## Product change notification (PCN)

| <b>Title / short description</b>   | AXL F BK ETH - function extension |
| <b>Change number</b>               | CDR260051-00                      |

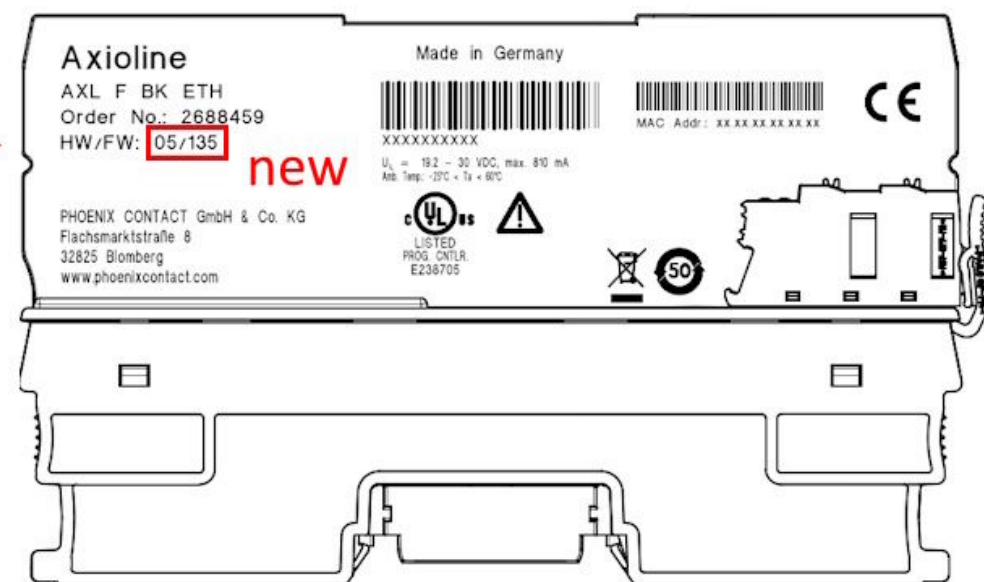
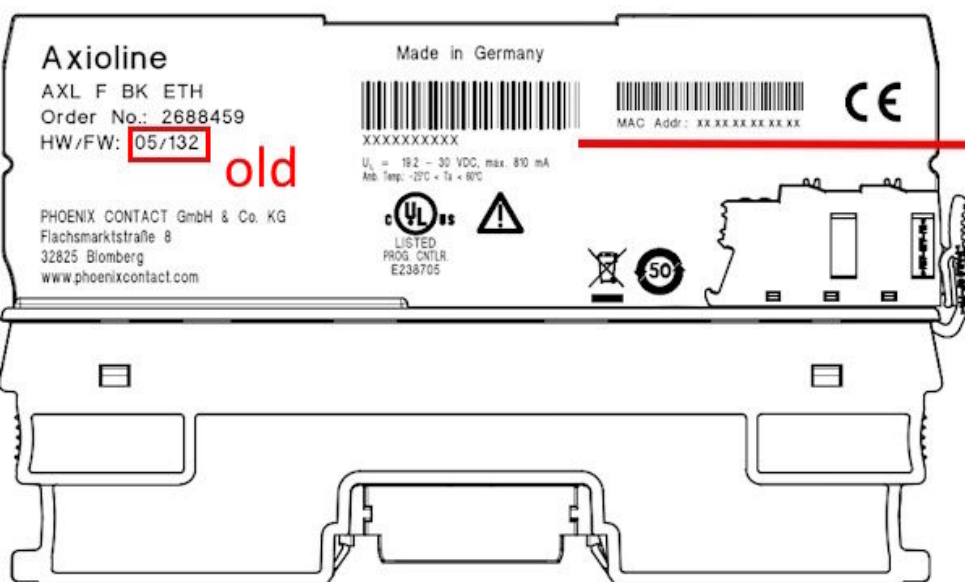
New functions:

- Extended SNMP MIB-2 Interface Table: Separate tables for both Ethernet ports added
- Added Modbus/TCP Register 2050: Ethernet Port Status

The firmware and v/c revision on the labels will increase.
